ADDENDUM

NO. 3

PROJECT: Raymond Community Centre, Washroom Addition /
Renovations, Muskoka Lakes Township

DATE: November 23, 2022

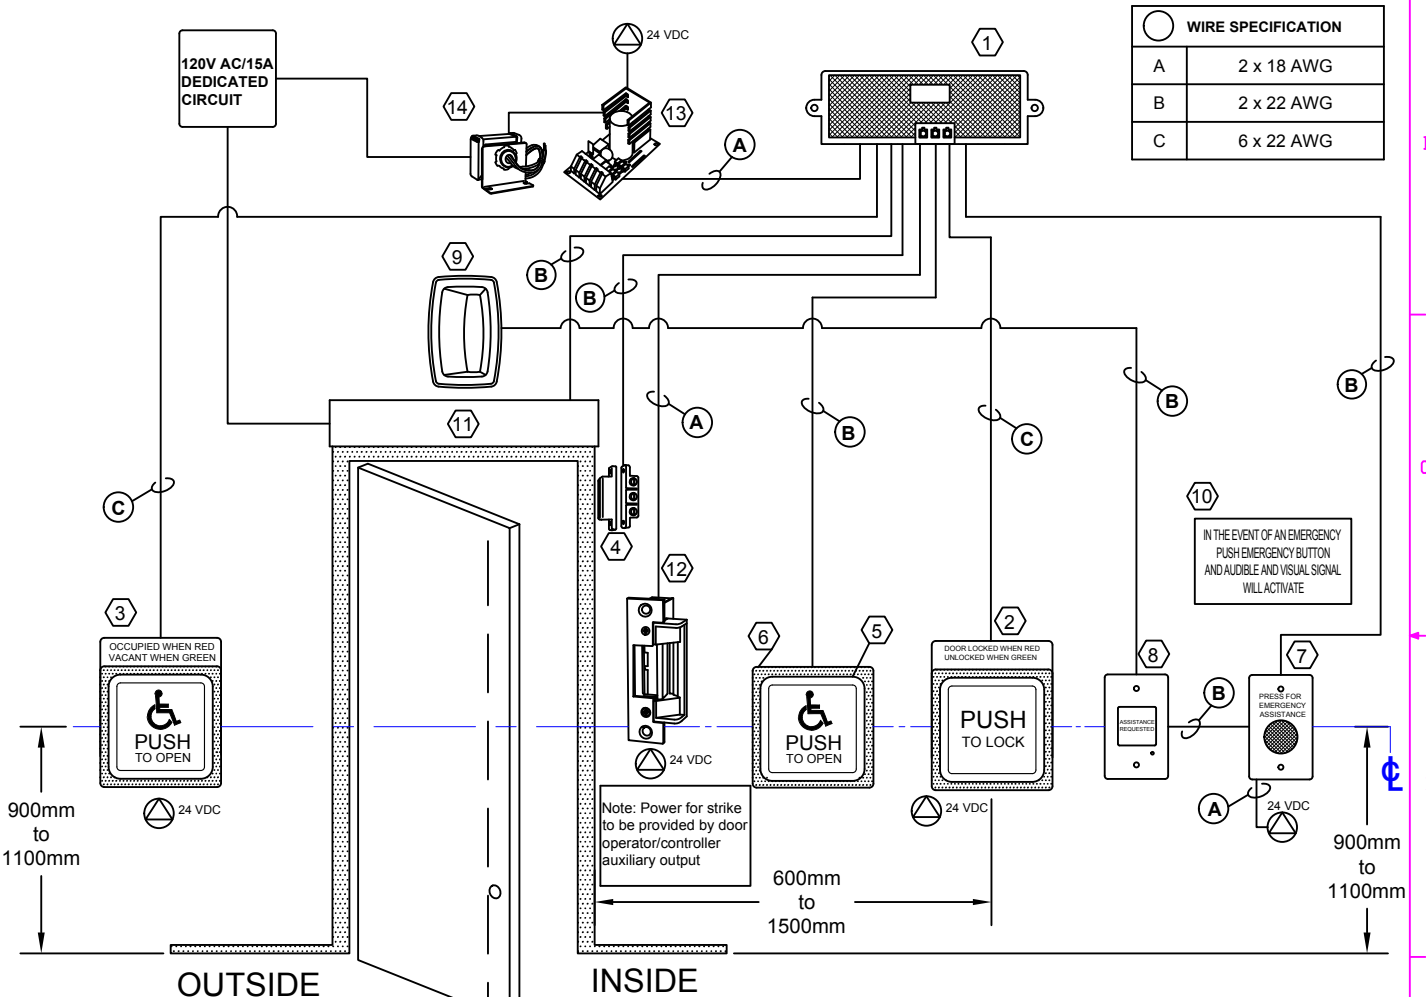
3. An auto-operator is indicated on detail 1/A-5. Supply and install Nabco model GT8710, complete with activation buttons and control system, Camden CX-WC13XFM (flush-mount). Provide power to all components from a dedicated circuit in the basement panelboard. Wiring diagram for control system enclosed.

1. Push Switches for the power door operator (Item 3 and 5) should be mounted with it's centre located not less than 900mm and not more than 1100mm above the finished floor and is located not less than 600mm and not more than 1500mm beyond the door swing where door opens towards the control (Item 5)

2. Wire Must Be Stranded, Multi-Colour.
